IREDELL COUNTY HEALTH DEPARTMENT

IMPROVEMENT PERMIT / CERTIFICATE OF COMPLETION / OPERATION PERMIT / EXISTING SYSTEM INSPECTION

PROPERTY DESCRIPTION NO. 20791 DATE 4/10/95 TAX MAP NO 9A-7-A-61

SUBDIVISION WOODROSE PARK BLOCK / SECTION ____ LOT 61 LOT AREA ~103'x72' SITE CLASS PS DESIGN FLOW 360 L.T.A.R. 0.35 GPD/FT²

INITIAL SITE SKETCH

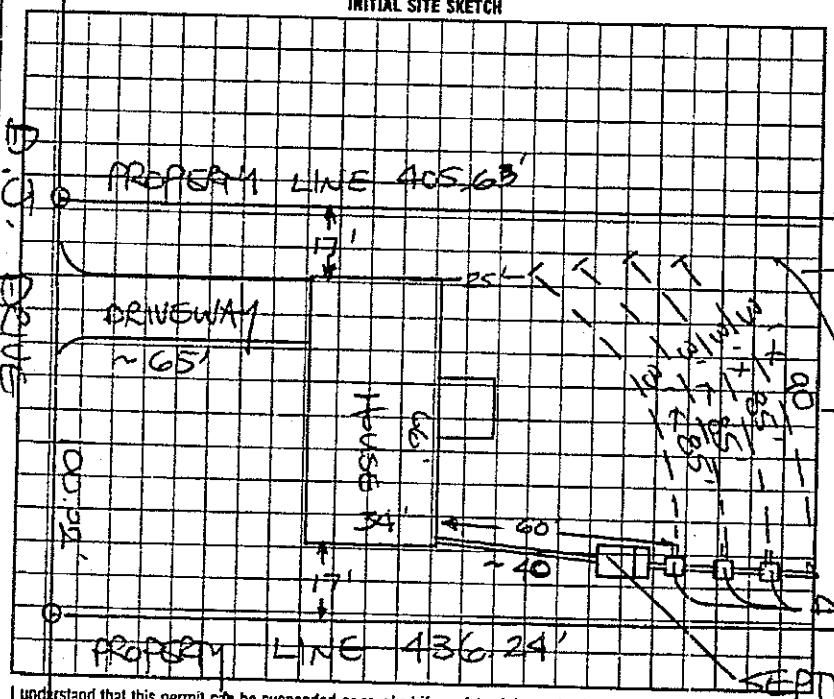
Comments: ① KEEP SYSTEM MINIMUM 15' FROM BASEMENT DRAIN 10' FROM PROPERTY LINE ② INSTALL LINES ON CONTOUR, NO DEEPER THAN 36", 9' APART MINIMUM AS CENTERS

AS BUILT SKETCH

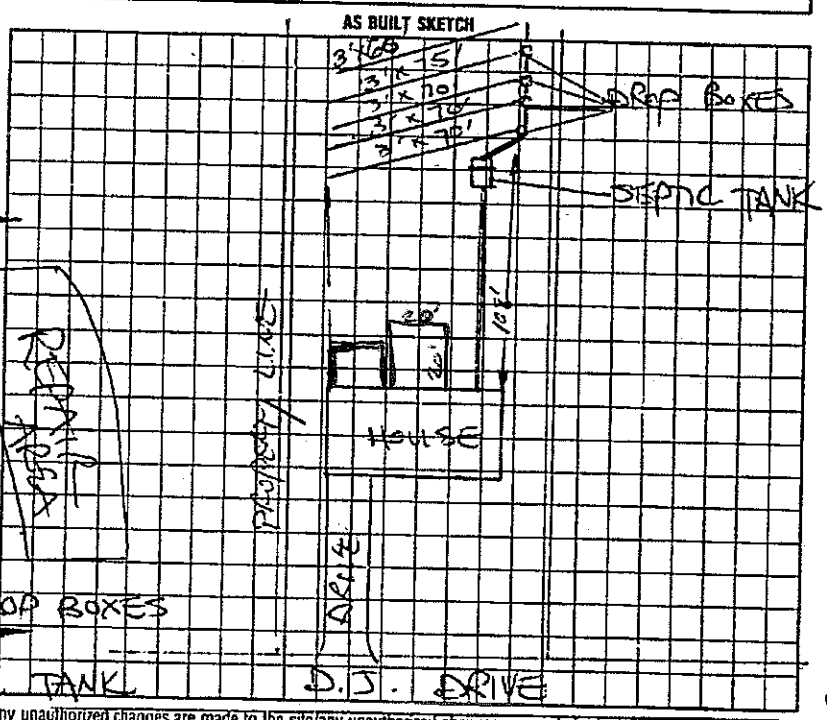
HEALTH DEPT. Location of the proposed Den Addition addition does not appear to impact the existing on-site septic system.**NOTE: ____ REHS
